INCH POUND
MIL-PRF-19500/548D
AMENDMENT 1
31 October 2002

PERFORMANCE SPECIFICATION

COUPLER OPTO ELECTRONIC, SEMICONDUCTOR DEVICE, SOLID STATE
TYPES 4N47, 4N47A, 4N48, 4N48A, 4N49, 4N49A, 4N47U, 4N48U, AND 4N49U
JAN, JANTX, JANTXV, AND JANS

This amendment forms a part of MIL-PRF-19500/548D, dated 8 June 2001 and is approved for use by all Departments and Agencies of the Department of Defense.

FIGURE 1. Dimensions and configuration (4N47, 4N47A, 4N48, 4N48A, 4N49, and 4N49A).”

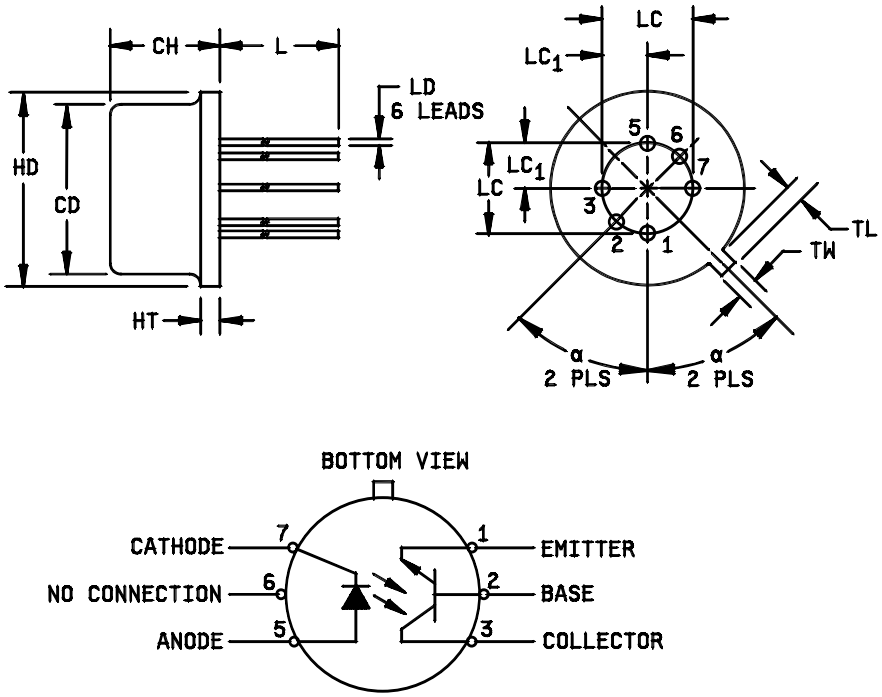
FIGURE 1, delete and substitute:
-
“

NOTES, add “6. Device types 4N47, 4N48, and 4N49 shall have the collector internally connected to case.”
